**To:** Interested Parties  
**From:** City of Beaverton Planning Division  
**Date:** November 22, 2019  
**Subject:** **PTF2019-001 / SDM2019-0002 / TP2019-002 Walker Road Improvements (NW 173<sup>rd</sup> to NW 185<sup>th</sup>)**

PROPOSAL: **NW Walker Road Improvements (NW 173<sup>rd</sup> to NW 185<sup>th</sup>)  
PTF2019-0001 / SDM2019-0002 / TP2019-0002**

**FACILITIES REVIEW COMMITTEE DRAFT  
TECHNICAL REVIEW AND RECOMMENDATIONS  
NW Walker Road Improvements (NW 173<sup>rd</sup> to NW 185<sup>th</sup>)  
PTF2019-0001 / SDM2019-0002 / TP2019-0002**

Figure 7. Noise Modeling Locations (2 of 2)

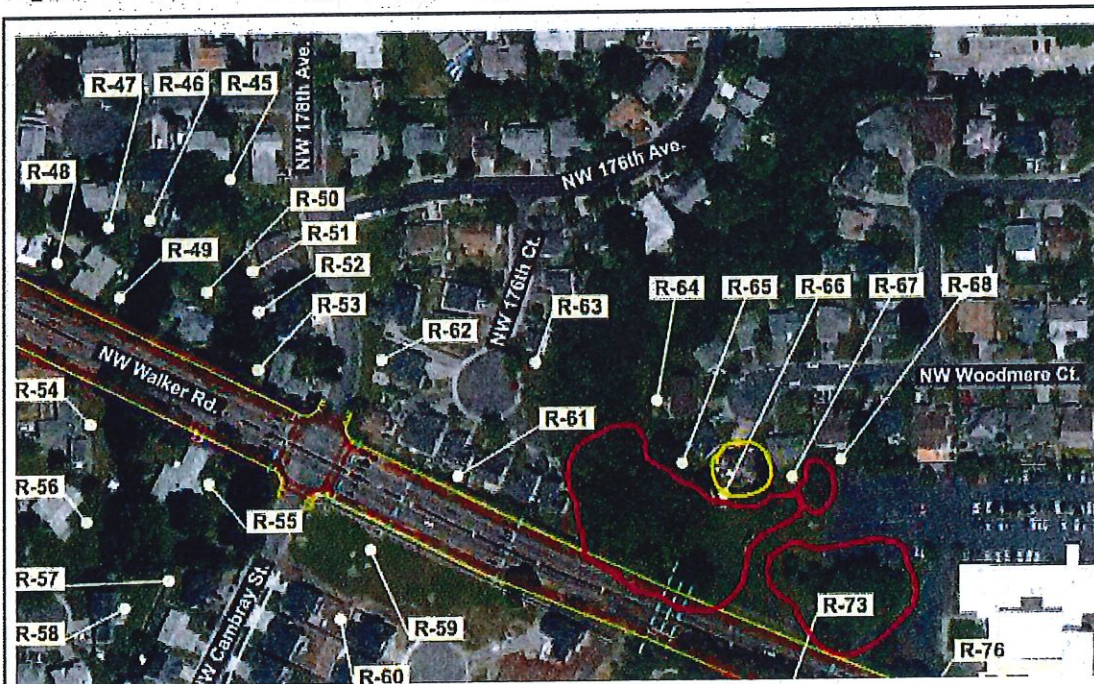
1. The recording was done in September. This means all the trees, their leaves and seasonal brush between Walker road and our cul-de-sac were present. Having lived here several years once Fall hits and the leaves drop the noise volume from Walker basically doubles. I do not feel this was accurately measured given the time the recording/monitoring was done. Considering close to half the year those leaves that insulate us from Walker are not present this seems like additional analysis is needed.

I've circled our house in yellow and all the trees in red between us and Walker.

Below is a picture looking towards walker today 10/07/2019. Notice you can barely see Walker. Once we hit Fall and the leaves drop Walker is completely visible. This means all the leaves reflecting and insulating the cul-de-sac from noise are not there. Post Fall when the leaves are gone is when noise levels need to be captured to make an accurate assessment.

2. The road height is changing. My wife and I attended a meeting a while back describing the proposed change. If I am recalling the meeting correctly the total height of the road is increasing to level out crossing the creek and allow more water flow through the culvert. I did not see that brought into the sound equation. In the above picture the black line is approximately how walker flows. From right to left coming from 185th towards 173rd. Walker dips down as it crosses over the creek and then goes uphill as it goes up to 173rd. Leveling Walker out more and raising the height will increase total volume we are exposed to. Is this going to be modeled? This seems like a gap in the analysis.

Figure 7. Noise Modeling Locations (2 of 2)

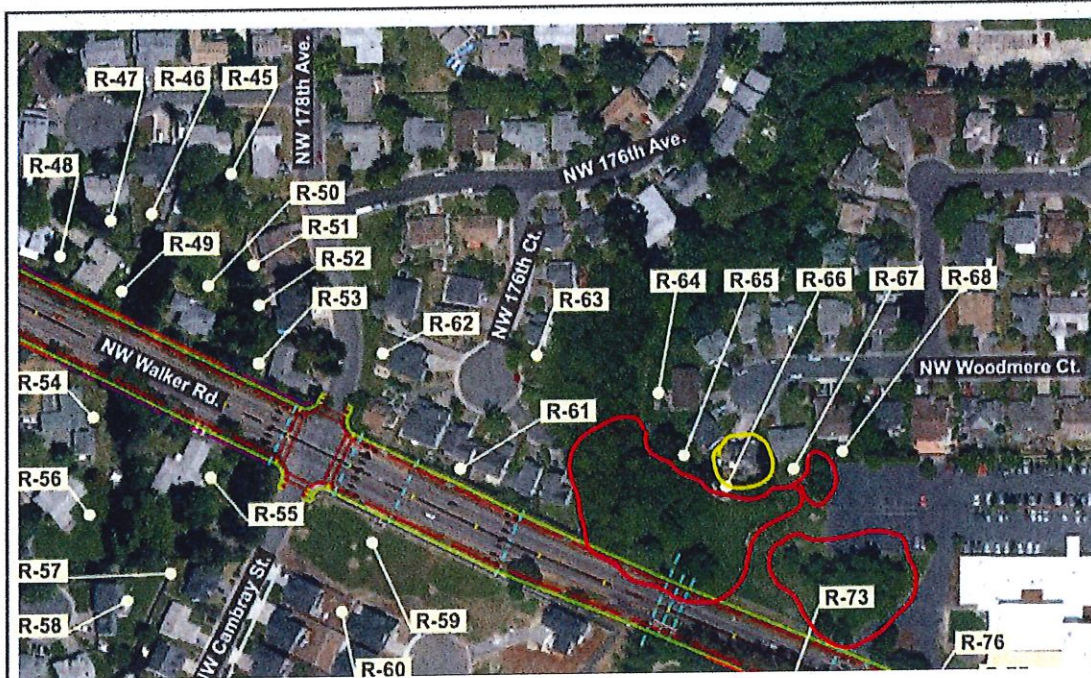
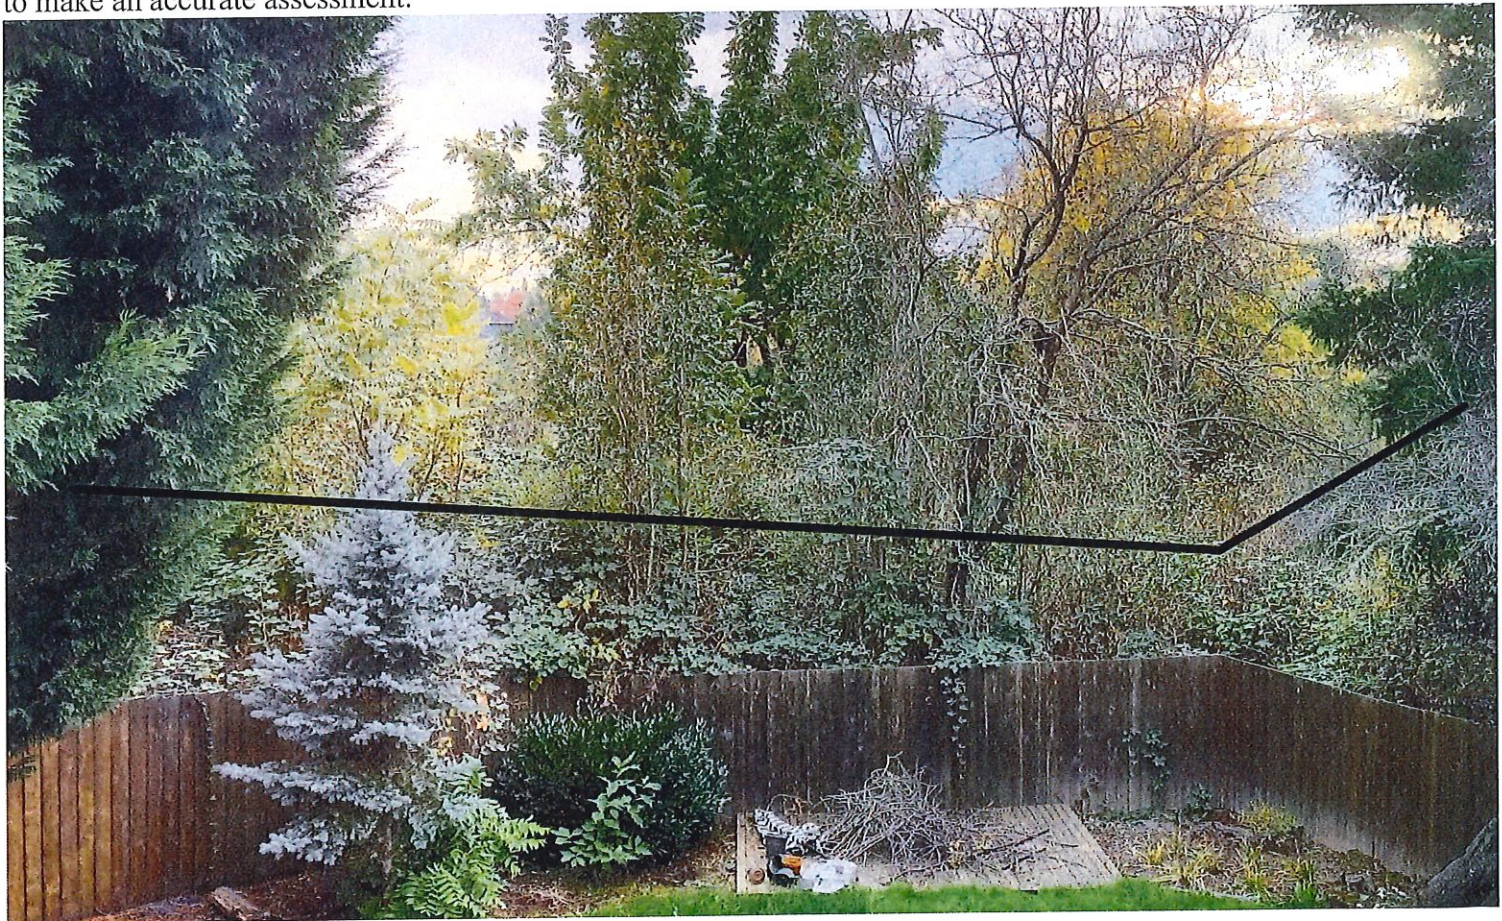
1. The recording was done in September. This means all the trees, their leaves and seasonal brush between Walker road and our cul-de-sac were present. Having lived here several years once Fall hits and the leaves drop the noise volume from Walker basically doubles. I do not feel this was accurately measured given the time the recording/monitoring was done. Considering close to half the year those leaves that insulate us from Walker are not present this seems like additional analysis is needed.

I've circled our house in yellow and all the trees in red between us and Walker.

Below is a picture looking towards walker today 10/07/2019. Notice you can barely see Walker. Once we hit Fall and the leaves drop Walker is completely visible. This means all the leaves reflecting and insulating the cul-de-sac from noise are not there. Post Fall when the leaves are gone is when noise levels need to be captured to make an accurate assessment.

2. The road height is changing. My wife and I attended a meeting a while back describing the proposed change. If I am recalling the meeting correctly the total height of the road is increasing to level out crossing the creek

**Response:** Washington County performed a traffic noise impact analysis for this project, a copy of which is posted on the project web site (need to verify). The subject property was one of several properties on Woodmere Court which were analyzed for traffic noise impacts related to the upcoming Walker Road improvement project. In the analysis, it was found that while noise levels would increase due to the widening project, the noise levels would still be below levels that the FHWA considers for noise abatement. Therefore, no noise walls were modeled or considered for the Woodmere Court area.

I would also defer to the response from Michael Minor regarding these comments
